Corinne R. Hollister

Reference: Tree Protection Guidelines and Response to Corrections

Site Address: 9167 SE 64th, Mercer Island 98040

Parcel: 3024059213 (West Lot)

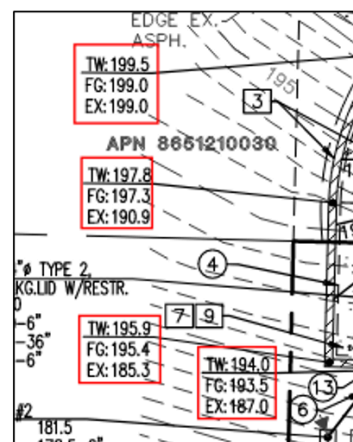
3. (For Civil from intake screening) See checklist for creating a tree protection plan. Show the building pad and all items in the checklist.
"https://www.mercerisland.gov/sites/default/files/fileattachments/community_planning_amp_development/page/21988/treessubmittalchecklist.pdf" [treessubmittalchecklist.pdf \(mercerisland.gov\)](https://www.mercerisland.gov/sites/default/files/fileattachments/community_planning_amp_development/page/21988/treessubmittalchecklist.pdf)

NOTE: Favero Greenforest indicated offsite exceptional trees #3557 and #3557.5 cannot be retained due to grade changes and associated fill. Those trees are currently shown as retained. Please show that these grade changes have been resolved or that

Tree Submittal Checklist submitted separately to Mr. Heard.

The proposed driveway will be constructed within the LOAD of offsite trees 3557 and 3557.5, two very large cottonwoods. The proposed encroachment is fill over the tree's rootplates from 6 to 7 feet above existing grade. See exhibit right for elevations.

Additionally, excavation for the NW corner of the proposed house will occur within a small portion the LOAD and dripline of these trees.

a tree well and/or retained will will be installed to protect those trees. If removal is required, coordination and agreement with the adjacent property owner is required.

Attachment 4: Annotated Site Illustration – Update Site Plans

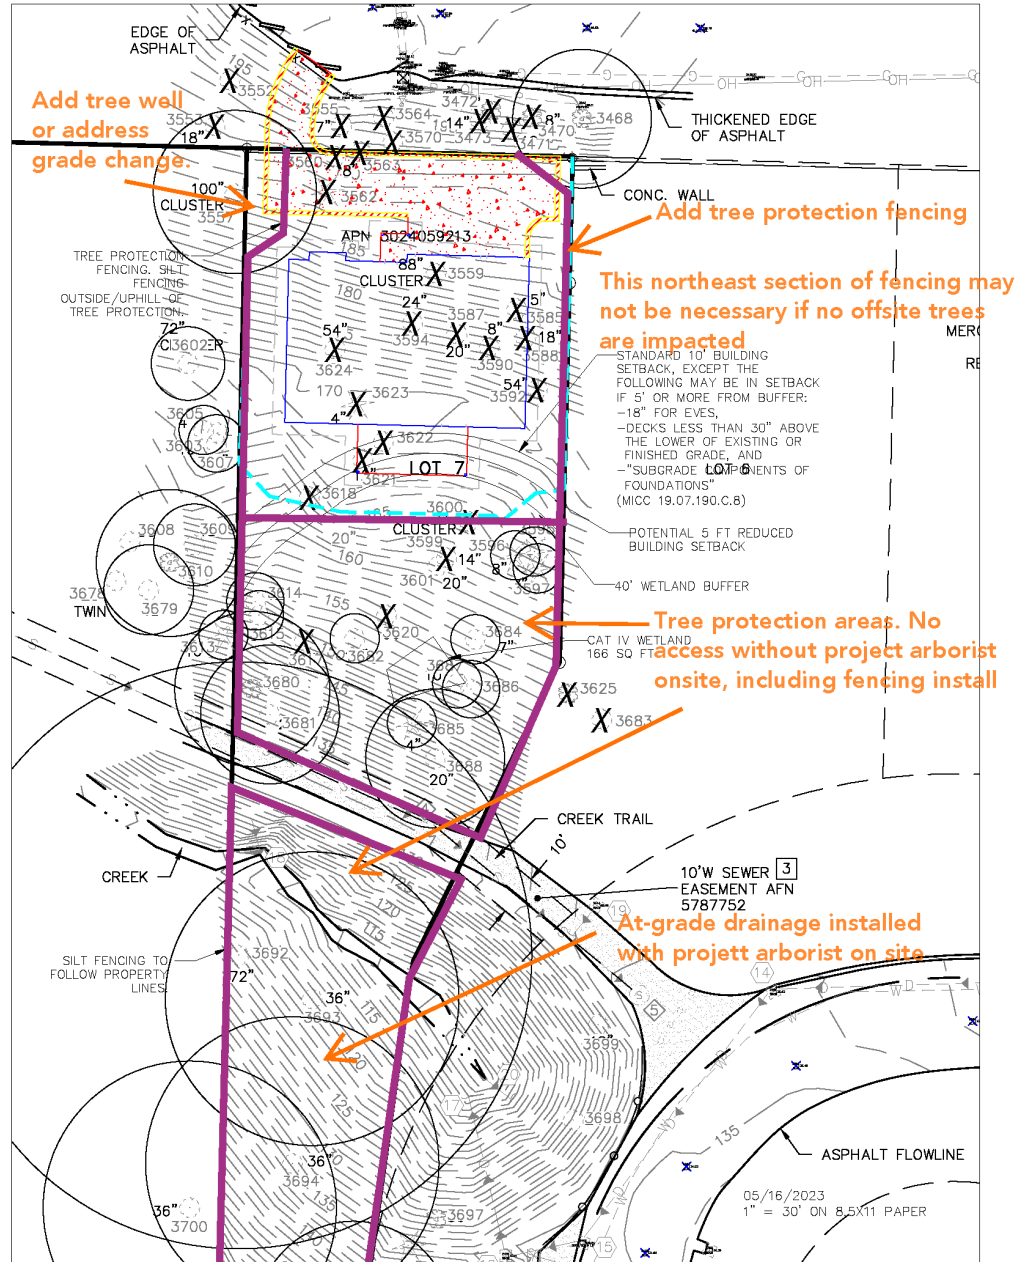
Tree protection fencing: A six-foot temporary chain-link fence or approved orange polyurethane equivalent shall be installed outside the driplines of all retained trees, as indicated on the annotated illustration in this report. All site plans shall be updated accordingly. Fencing shall be installed before any site disturbance, demolition or construction, and after tree removal and pruning for clearance is complete. The project arborist shall be onsite during fencing placement that crosses inside any dripline areas of retained trees to monitor and document any impacts. Fencing material, placement and any modifications to tree protection measures shall be approved by the project arborist or a city planner.

Attachment 5: Recommended Replacement Tree Locations

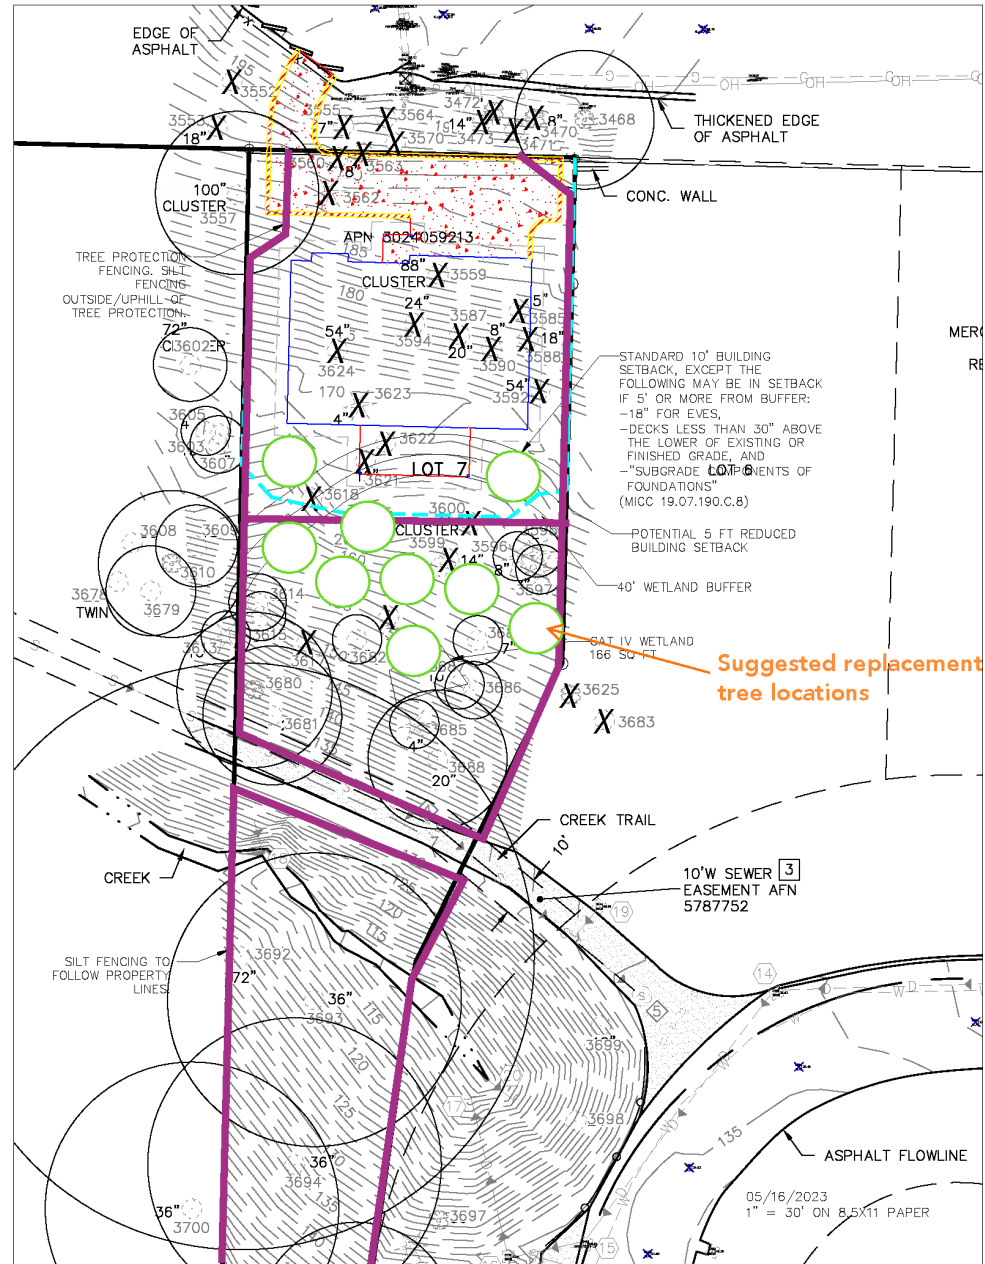
2. (For Architect from intake screening) A replanting plan will be required. The arborist report indicates many exceptional grove trees are proposed for removal. These exceptional grove trees will require six replacement trees for every tree removed. A replanting plan should be created according to the following. The trees need to be at least 10' apart from each other, structures, fences and utilities. If requested and you can show no room exists on site for all the trees, the remainder can be a fee in lieu if requested. At least half of the trees need to be Pacific Northwest native, see the following link https://oregonstate.edu/trees/name_common.html. A tree watering plan that conforms with your geotechnical engineers recommendations must also be submitted to ensure the trees survive long term. **A replanting plan is included in this report with notes on irrigation to ensure trees establish and survive.**

Nine (9) of 21 required. See pages 6-7.
